# Access Compliance Report

## Public Rights-of-Way

### (Curb Ramps)

Intersection ID: 23772	Main Street: KNIGHTSWOOD_DR	Cross Street: OLD_FORGE_DR	Location: NE
ADA ID: C908DBC0FE3E	Ramp Type: PerpDiag	Initial Pass/Fail: Pass	Overall Compliance: No
		Severity Score: 10

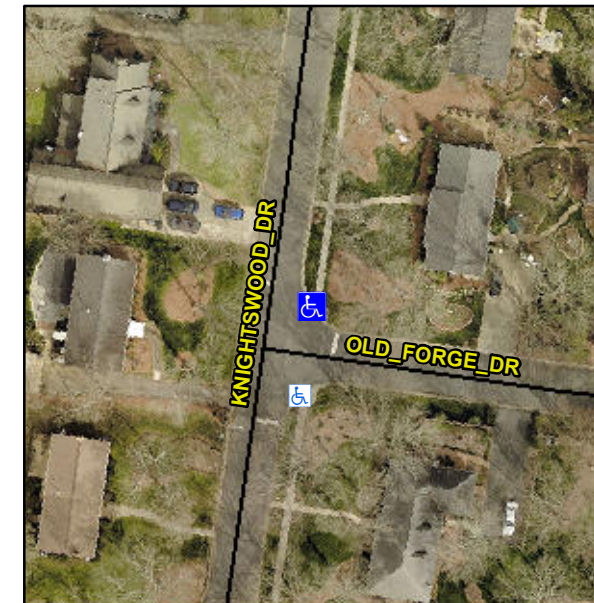
**Not Found, R304.2.1, R304.2.2-Perp, R304.3.2-Para, R304.5.3, R305.2**

Compliance	Description	Data	Compliance	Description	Data
N/A	Ramp Length (in)	60.5	Yes	Ramp Slope (%)	5.2
Yes	Ramp Width (in)	48.0	Yes	Ramp XSlope (%)	1.9
N/A	Flare Type LT	Sloped	N/A	Flare Type RT	N/A
N/A	Flare Slope LT (%)	2.7	Yes	Flare Slope RT (%)	1.4
N/A	Flare Traversable LT?	Yes	N/A	Flare Traversable RT?	Yes
No	Landing Length (in)	N/A	Yes	DWS Provided?	Yes
No	Landing Width (in)	N/A	Yes	DWS Contrast?	Yes
No	Landing Slope (%)	N/A	Yes	DWS Length (in)	24.0
No	Landing X Slope (%)	N/A	Yes	DWS Full Width?	Yes
N/A	Landing Curb? (Y/N)	No	No	DWS Offset (in)	6.0
N/A	Shared Landing?	N/A			
Yes	Gutter Ponding?	No	Yes	Gutter Slope (%)	1.8
Yes	Gutter Lip Ht (in)	0.0	Yes	Gutter X Slope (%)	0.5
N/A	Painted X Walk1?	No	N/A	Painted X Walk2?	No
	X Walk 1 Direction	To NW		X Walk 2 Direction	To SW
N/A	X Walk 1 Width (in)	N/A	N/A	X Walk 2 Width (in)	N/A
	X Walk 1 Slope (%)	1.8		X Walk 2 Slope (%)	2.6
	X Walk 1 X Slope (%)	2.3		X Walk 2 X Slope (%)	1.3

**Remove & Replace Curb Ramp With Two New Directional Ramps or Equivalent.**
